CCK-2669-23 ADDENDUM# 1 11/23/2022

UK Indoor Track Facility

CCK-2669-23 Indoor Track JRA Project No. 202258 UK Project 2584.0 University of Kentucky Lexington, Kentucky

The Addendum will form a part of the Contract Documents and modifies the original Bidding Documents dated October 2022.

UK Cliff Hagan Stadium Post Demolition Survey

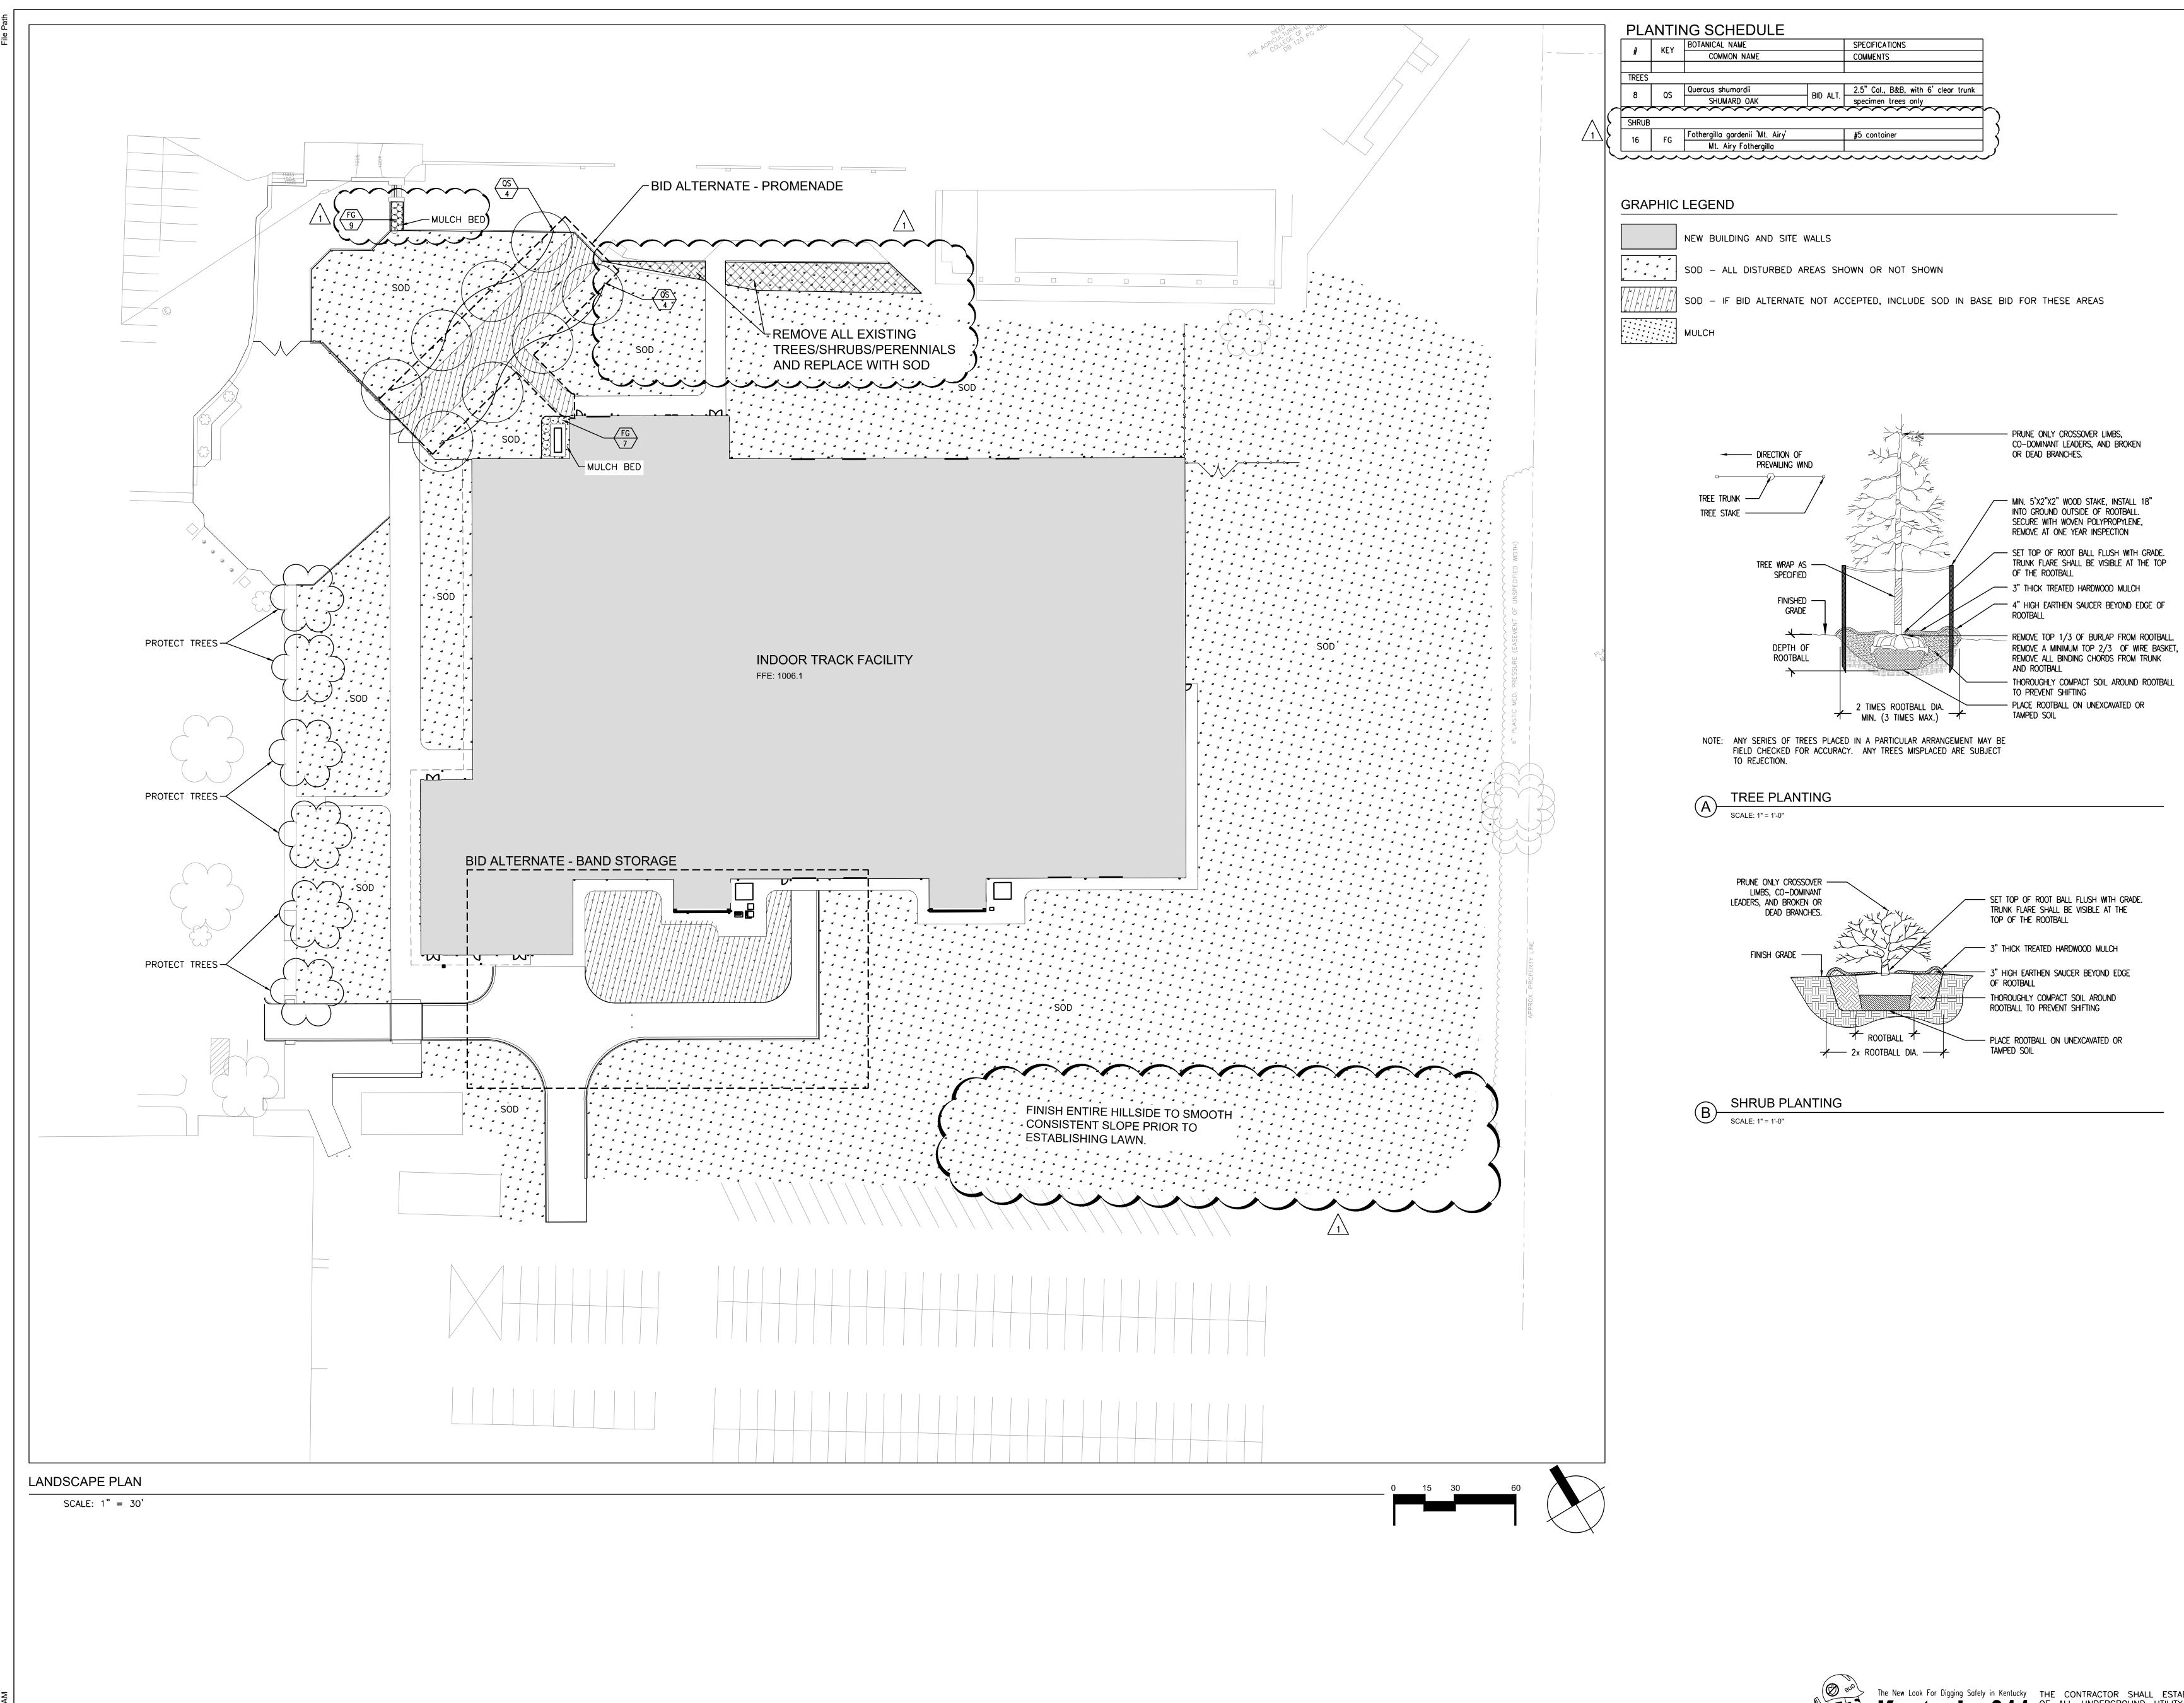
Refer to attached post demolition topographic survey. This survey is available upon request in the form of an AutoCAD file.
